TECHNICAL NOTE
■ Changing out from GE 2.3 to Nidec PerfectSpeed DC Motors in the field

■ MAC 10 Motor Cable Configurations

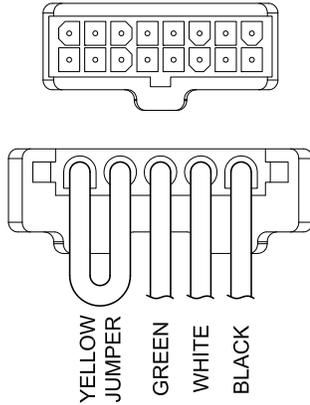
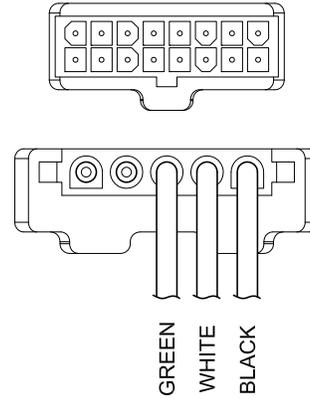
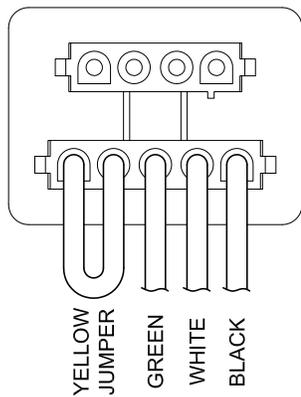
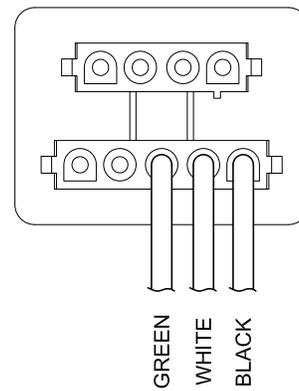
When you order a replacement motor they will be a form and fit replacement, except for the cable that connects to the control board and the motor. The new Nidec motor will require you to replace the cable. The old cable was a sixteen pin connector while the new motor cable will have a four pin connector as shown in the photo to the right.

Please use the new cable with the new four pin connector to connect your new motor. The cable number will be determined by the build style of your unit.

The power cable, has remained the same for the new motor and will be reused. The rest of the fit and function will be a direct replacement. Follow the procedure in the IOM for motor swap for your particular FFU.
